TOLERANCES	WESTERBEKE CORPORATION AYER MA. 02322
INCHES: .XX ±.03, .XXX ±.005, FRACT. ±.05, ANGLES ±.5°, FINISH 32	MILLIMETERS: .X ±.5, .XX ±.13
TITLE: WIRING DIAGRAM, 15.6 BTDA, 20, 25, 32 BED W/ELECTRONIC GOVERNING	
DRAWN BY: WRM	DATE: 8/7/2000
APPROVED BY	DATE
DIMENSIONS: INCHES / MILLIMETERS (UNLESS OTHERWISE SPECIFIED)	SCALE: NONE
SHT. 1 OF 1	SIZE: E
DRAWING NUMBER: 39422	REV. E

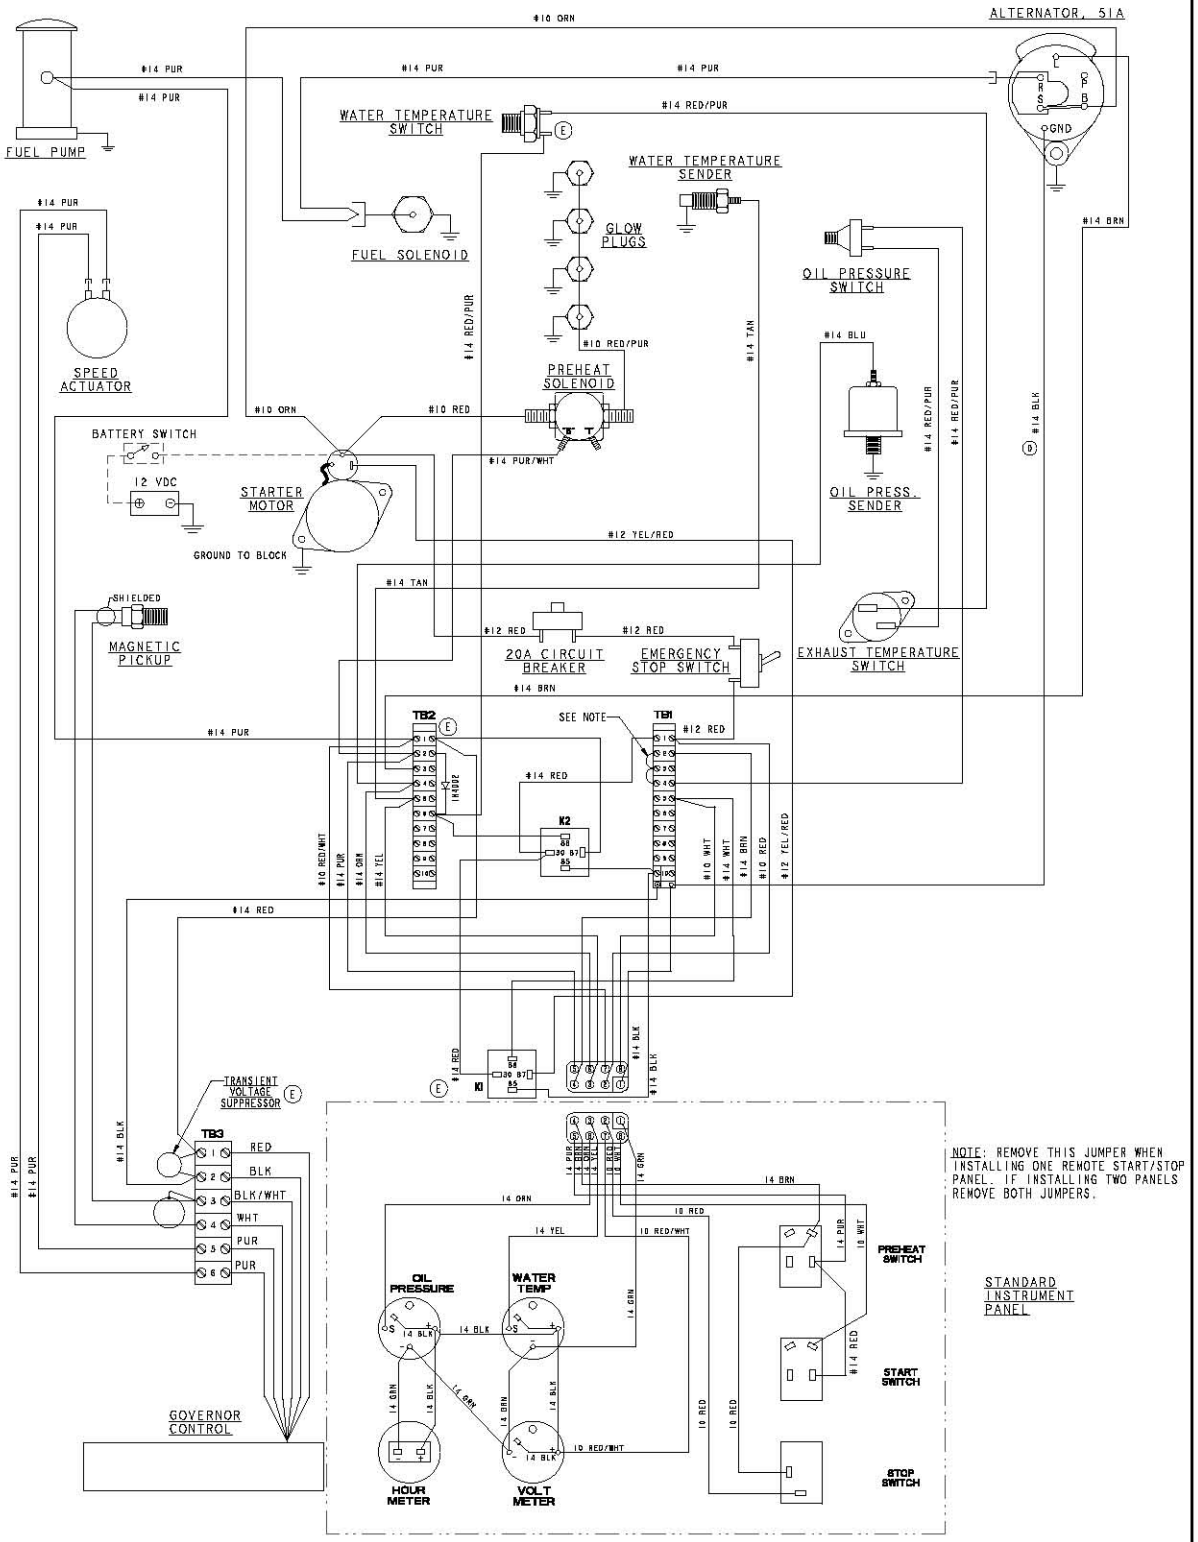
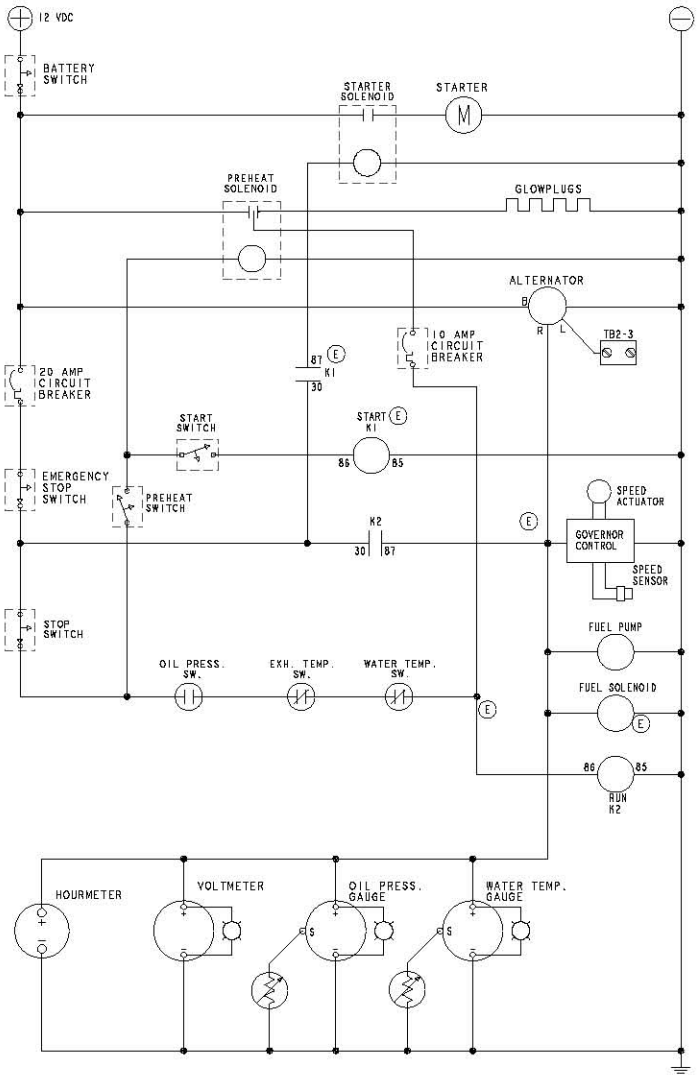
ECO NO.	DATE	REV.	REVISION RECORD	AUTH.	DR. BY
2083	1/27/93	A	ADDED RELAY TO THE CONTROL BOX: WIRING RAN FROM TB1-3 TO EXHAUST TEMP. SWITCH TO O.P. SWITCH TO WATER TEMP. SWITCH. ROW FROM TB1-3 TO O.P. SWITCH TO EXHAUST TEMP. SWITCH TO WATER TEMP. SWITCH		WRM
2193	6/14/93	B	TERMINAL BLOCKS TB1 AND TB2 WERE 5 POSITION BLOCKS, NOW 10 POSITION BLOCKS		WRM
2716	4/11/95	C	O.P. SW. WAS CLOSED; EX. TEMP SW. WAS OPEN		MKM
3081	10/9/96	D	CHANGE ALT. GROUND WIRE FROM GRN TO BLK		BRN
4664	8/3/00	E	ADDED RELAY K2, REWIRE 10A C.B.; ADDED CONNECTION TO GOVERNOR FROM FUEL PUMP. ADDED TRANSIENT SUPPRESSOR TO CIRCUIT.		TSM
